City of Surrey  
**PLANNING & DEVELOPMENT REPORT**

File: 7917-0489-00

Planning Report Date: September 17, 2018

**LOCATION:** 13097 - 64 Avenue

SCALE	REV 02	TITLE: SITE LAYOUT	DRAWING NAME: A0
-------	--------	--------------------	------------------

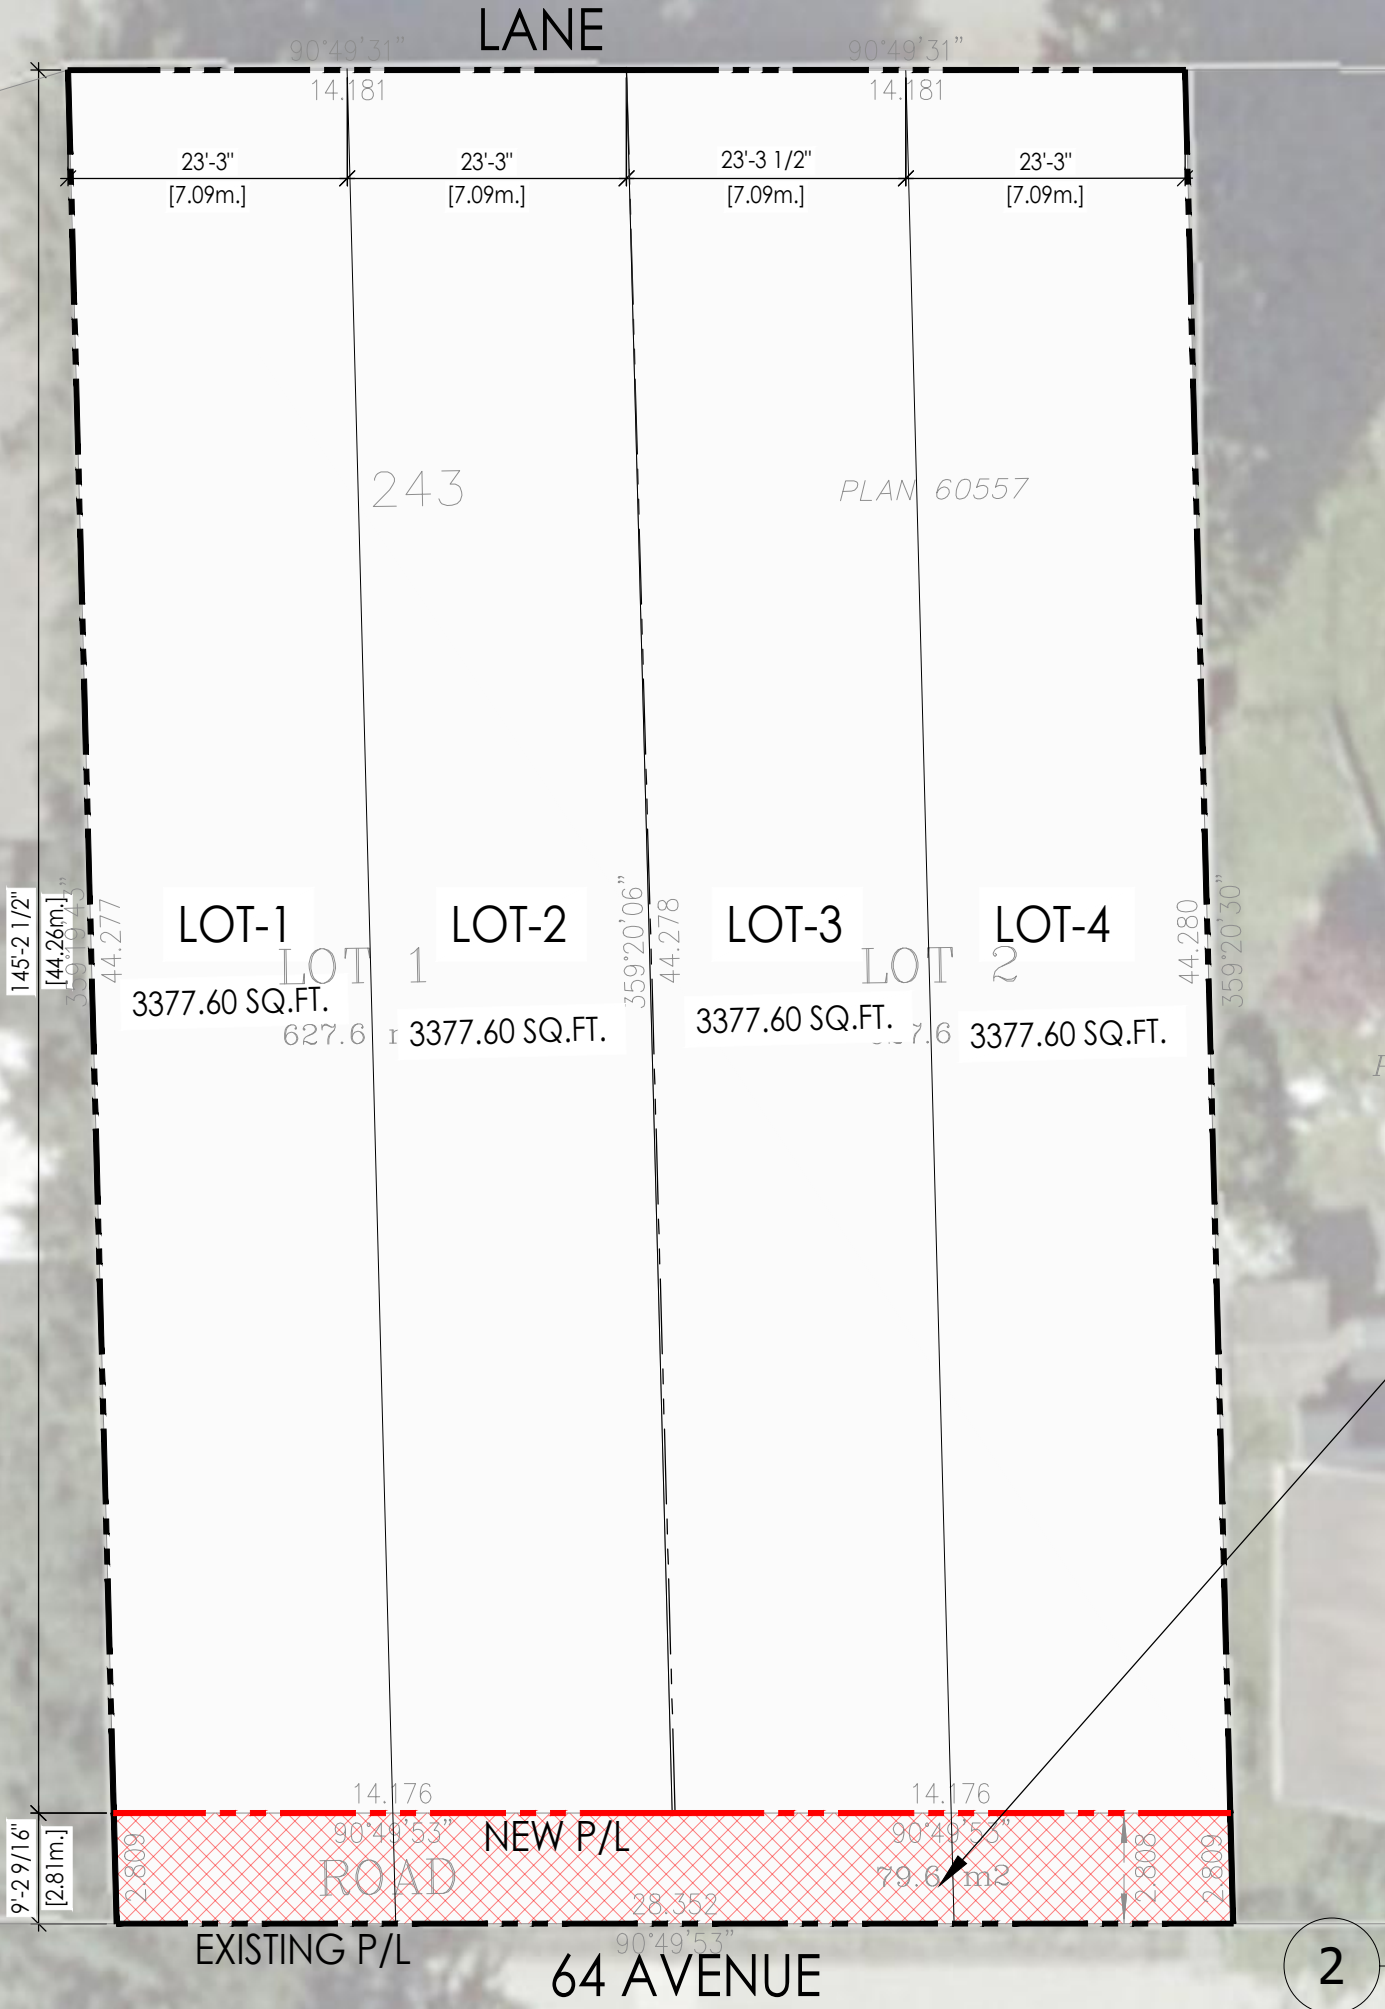
- To reduce the minimum lot width for an interior lot in the "Semi-Detached Residential Zone (RF-SD)" from 7.2 metres (24 ft.) to 7.1 metres (23 ft.), for proposed Lots 1 to 4.

- The proposed 7.1 metre (23 ft.) lot widths are 0.1 metres (10 cm) less than the required 7.2 metres (24 ft.) for interior lots and allows for an efficient RF-SD subdivision where lots are necessary to be in pairs. This reduction represents less than a one (1) percent reduction in relation to the required lot width.
- The proposed lot depth of 44.3 metres (145 ft.) is deeper than the minimum requirement of 28 metres (90 ft.). Further, the proposed 313 square metres (3,377 sq. ft.) lot area exceeds the 200 square metre (2,150 sq. ft.) minimum of the RF-SD Zone.
- The requested variance to the lot width will be visually unperceivable along the streetscape.

4. Surrey Zoning By-law, 1993, No. 12000, as amended is varied as follows:
  - (a) In Section K of Part 17H "Semi-Detached Residential Zone (RF-SD)", the minimum interior lot width is reduced from 7.2 (24 ft.) to 7.1 metres (23 ft.) for Lots 1 to 4.
